Work Order ID 85895

Item Name: 205 Skidtube bent detail

DRAWING NO. D2580	TITLE 205 SKIDTUBE ASSEMBLY	REV. E	DART AEROSPACE LTD ENGINEERING ORDER	D.E.O. NO. D2580-E-1	SHEET NO. SHEET 1 OF 1	SCALE NTS
DRAWN <i>UP</i>	CHECKED <i>ASS</i>	MFG. APPR. <i>ER</i>	APPROVED <i>[Signature]</i>	DE APPR. <i>[Signature]</i>		
DATE 11.12.13	DATE 11.12.13	DATE 11.12.13	DATE 11.12.13	DATE 11.12.13

CHANGE ALL C'BORED WELDED CROSSBOLT SPACERS TO SWAGED SPACERS

SECTION B-B D5-2
SCALE 5X

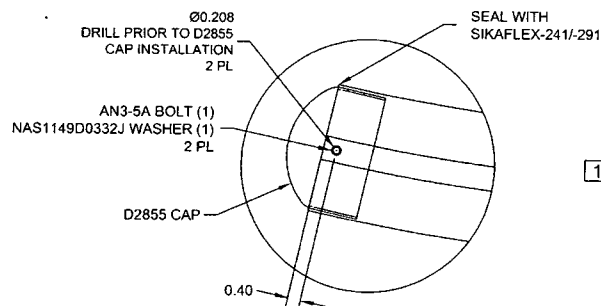
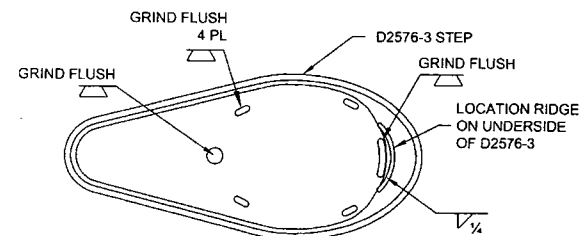
AFTER DRILLING AND BENDING ASSEMBLY
PERFORM THE FOLLOWING FOR Ø0.508 HOLES ONLY:
1. CHAMFER HOLE 0.050 X 45°
2. INSERT D2579 SPACER (20 PLACES)
3. WELD INTO PLACE AND GRIND FLUSH
4. C'BORE D2579 SPACER TO Ø0.437 X 1.00 DEEP

1. INSERT D4202-1 SPACER, 20 PL (-041) OR 20 PL (-045) OR 25 PL (-047)
2. SWAGE TO Ø0.437 X 1.00 DEEP PER QSI 002
3. TRIM / GRIND FLUSH PER QSI 002

SECTION B-B, F-F, I-I
NOT TO SCALE

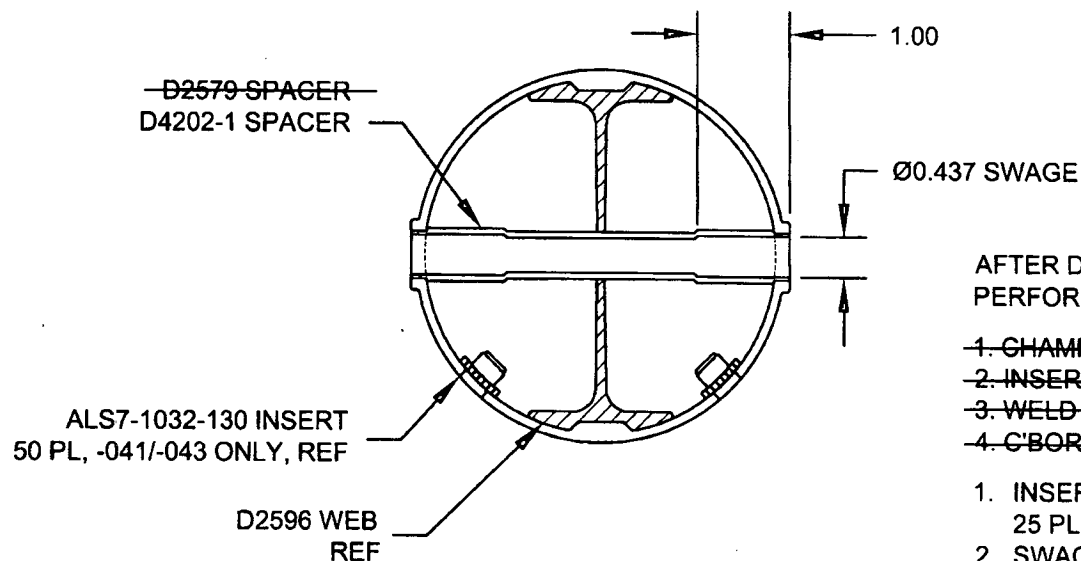
SECTION B-B, SECTION F-F, & SECTION I-I ARE AMENDED AS FOLLOWS
FOR ALL HOLES THAT WERE ORIGINALLY C'BORED:

- ~~1. CHAMFER HOLE 0.050 X 45°~~
- ~~2. INSERT D2579 SPACER (20 PLACES)~~
- ~~3. WELD INTO PLACE AND GRIND FLUSH~~
- ~~4. C'BORE D2579 SPACER TO Ø0.437 X 1.00 DEEP~~
